# Service Bulletin

**SUBJECT: Special Coverage Adjustment - Shift Lever May Not Display Correct Gear**

**MODELS: 2007-2008 Saturn AURA  
Equipped with 4-Speed Automatic Transmission (ME7/MN5)**

1765068

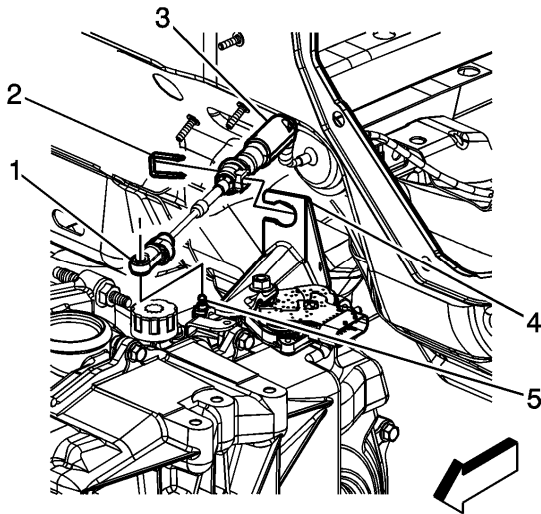
- Remove and discard the cable bracket (4).
- Install a new floor shift control cable and new bracket. Refer to *Floor Shift Control Cable Replacement* in SI
